Girder bridge. Estimate of Rs. 9460 for constructing
a ——— in the 65th mile of Road No 2 from Madura
to Rannad, sanctioned with remark

GOVERNMENT OF MADRAS.

Name of work... Constructing a
Girder Bridge in the 65th
mile on Road No. 2
Madusa to Ramnath
Amount of Estimate Rs 9,

Name of work Constructing a Girder
bridge of 5 spans of 25 ft each
across a Surplus Channel
from Ramnad tank at 65th
mile of Road No 2 Madurai to
Ramnad in the Madurai
District.

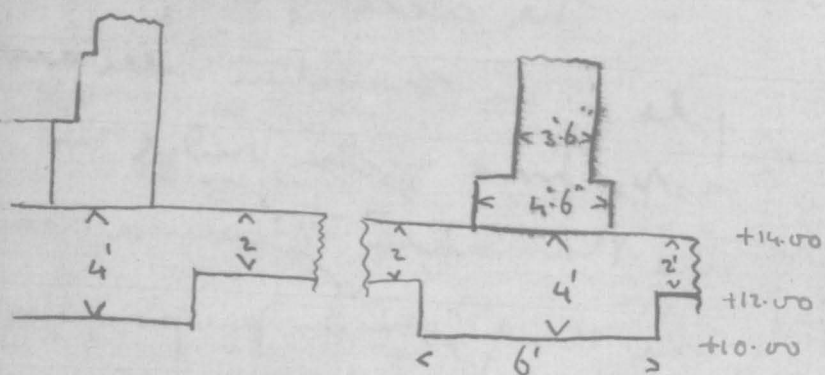
A serious mistake in the design of the bridge has up till now been overlooked.

The waterway provided has been based on the assumption that the flow level of the bridge is at +14.00, which is a little lower than the present bed of the

This is obviously a mistake.
The floor between piers should
be at +14.00 but is now proposed
to have the ground of the bridge
as follows -

Permission is requested to
revise the lot & correct the
plan accordingly

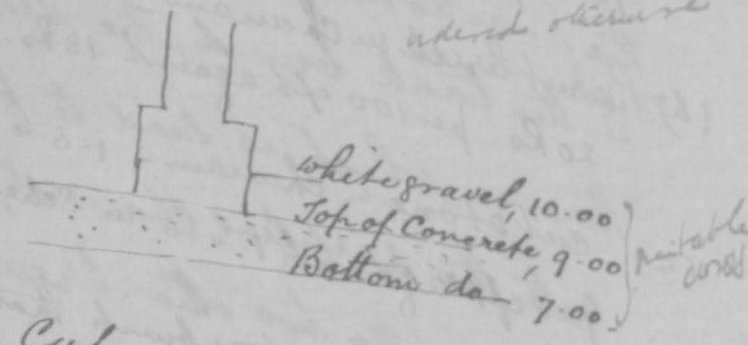
Something wrong in the quantity of discharge through the breaches and it cannot be checked without Long & Cross Sections of the breaches.

into the surplus channel, and those of the two other breaches, which it is said, will not affect the bridge, are not shown -

Owing to so many defects pointed out above, I beg to submit as necessary to know the Drainage area of the C.B. above the tank so that the actual quantity of surplus from the tank may be ascertained and the water-way of the bridge designed accordingly.
